FAX COVER SHEET

PRELIMINARY COMMERCIAL CHECKLIST

FILE NAME: La Quinta

DATE: January 22, 2007

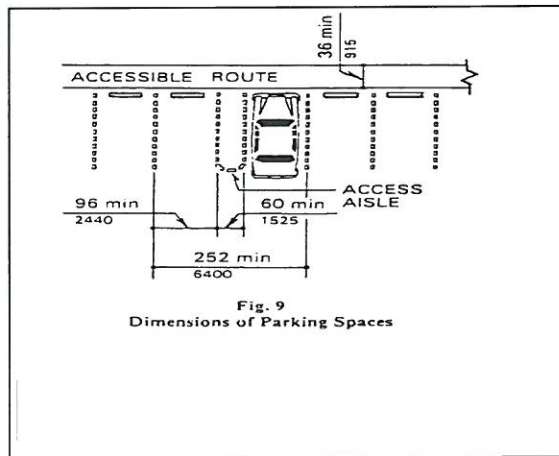
- b. Dead end travel lanes – Dead end travel lanes should only be provided when servicing 90 degree adjacent parking. In such circumstances, an area at least 10 feet deep by 24 feet wide backing provided at the end of the lane to accommodate turning movements.

COMMENTS: Please add the dead end travel lane by parking spaces 16 & 25 and 31 & 41. Please correct and show on the site plan (11" X 17").
